Manufacturing Bulletin

Subject: Product shipment in trays

Date: 9 Jul 2010

<u>Manufacturing Bulletin</u>
Attachment I

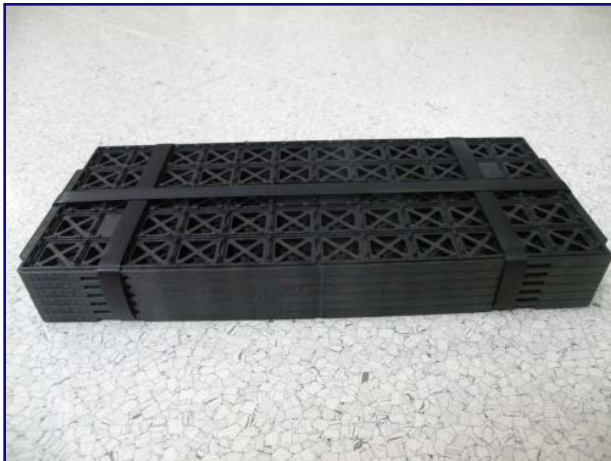
- 5+1 per bundle.
- 2+1 strap per bundle.
- Without end-cap.

- 4+1 per bundle.
- 3+1 strap per bundle.
- With end-cap (2 pieces per bundle).
